PHILLIPS 66 LOS ANGELES REFINERY PROPOSED CRUDE OIL STORAGE CAPACITY PROJECT

COMMENT LETTERS RECEIVED ON THE DRAFT ND AND RESPONSES TO COMMENTS

Comment Letter No. 1
Department of Transportation, September 17, 2013

Comment Letter No. 2
Communities for a Better Environment, Ms. Julia May, October 9, 2013

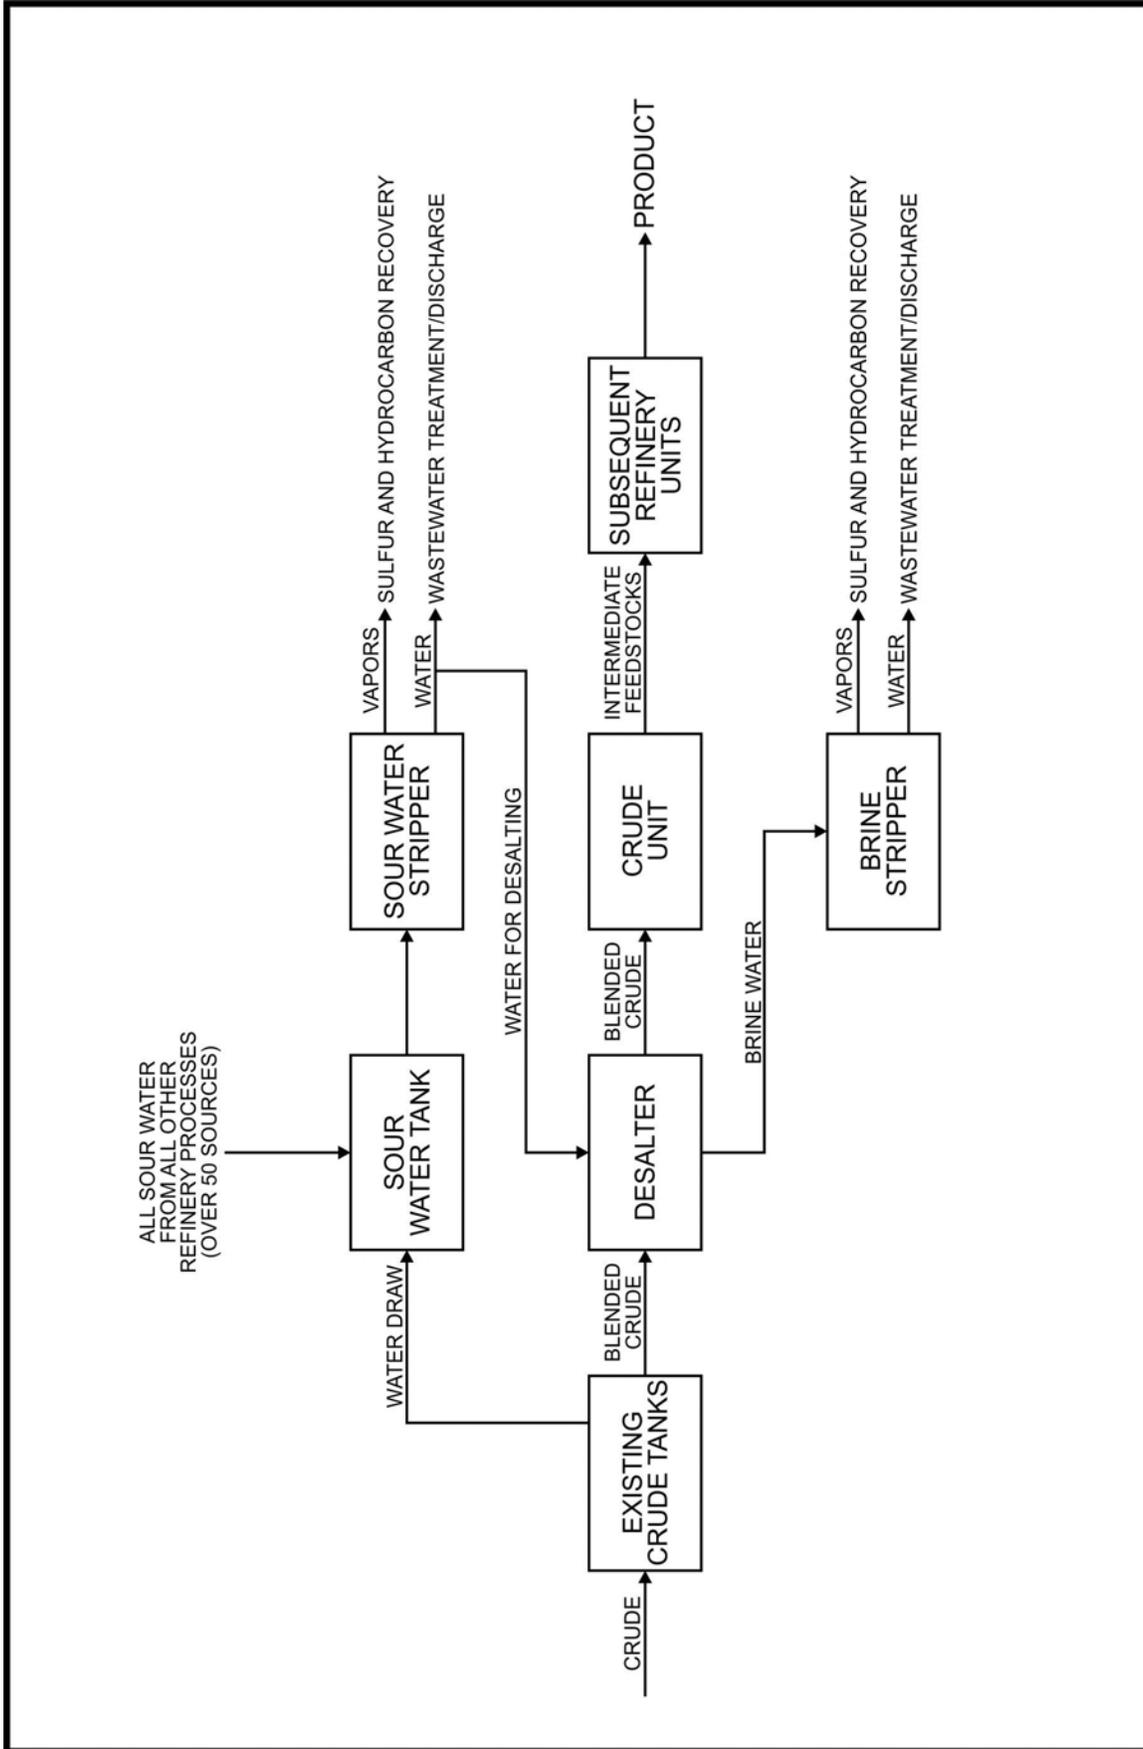
The commenter incorrectly assumes that the Refinery will be processing different crude oils and that the new heat exchangers for water treatment will be used as a new source of energy to process heavier crude oils. The Refinery currently processes crude oil blends that consist of a variety of crude oils including the North American crude oils mentioned by the commenter. While the individual crude oils purchased by the Refinery continually change with market availability and demand, the crude oil blend that is processed through the Crude Unit must stay consistent to meet the processing constraints of the Refinery operations. The commenter's opinions do not take into account the processing of a crude oil blend, and thus do not reflect the operations at the Refinery. (See Valero Crude by Rail Draft EIR, Appendix K, June 2014, available at http://www.ci.benicia.ca.us/vertical/Sites/%7B3436CBED-6A58-4FEF-BFDF-5F9331215932%7D/uploads/Appendix_K_McGovern_Report.pdf that explains how the Benicia Refinery must process a blended crude due to the Refinery's processing constraints.) As explained on page 2-18 of the Draft ND, the same constraints on American Petroleum Institute (API) gravity, sulfur content, and the Total Acid Number or TAN exist at the LARC. Therefore, the commenter's opinion that significant environmental impact will result from the processing of shale oils and tar sands crude oils will not occur at the Phillips 66 Refinery. Also, the new heat exchangers will be used to heat wastewater prior to processing in the Brine Stripper. As stated on pages 1-8 and 1-9 of the Negative Declaration, the Brine Stripper is a wastewater treatment unit; it is not a unit that processes crude oil (see Response 2-10 and Figure F-2). For these reasons, the commenter's conclusions are based on unsubstantiated opinions not related to the facts of this project and do not amount to substantial evidence of a significant impact (see Response 2-9). Lastly, the commenter has not provided any evidence or facts that would contradict this description of the processing configuration.

The existing configuration of the crude oil storage tanks, Desalter Unit, and Crude Unit are depicted in Figure F-2. This figure also shows the two wastewater treatment units: the Sour Water Stripper and the Brine Stripper. Crude oil stored in tanks is routed to the Desalter Unit for removal of salts and water prior to being fed to the Crude Unit. Some of the water present in crude oil is separated by gravity in storage tanks, and forms a water layer below the crude oil in the tank (since water is heavier than oil). This water layer is periodically removed from the storage tank and is termed the “water draw”. Currently, the water draw from existing storage tanks is routed via the sour water tank to the Sour Water Stripper. The sour water tank currently stores sour water³ recovered from units throughout the refinery. The Sour Water Stripper removes sulfur and hydrocarbon vapors from the wastewater.

The Desalter uses partially treated water from the Sour Water Stripper as wash water to remove salts such as calcium chloride, magnesium chloride, and sodium chloride from the crude oil feed.

The crude oil then leaves the Desalter and is processed in the Crude Unit. The salts-containing wash water leaving the Desalter is termed “brine” and is routed to the Brine Stripper for wastewater processing. Both the Brine Stripper and the Sour Water Stripper treat wastewater by removing sulfur and hydrocarbon vapors. In summary, the Desalter treats crude oil and removes salts; the Brine stripper treats wastewater and removes sulfur and hydrocarbon.
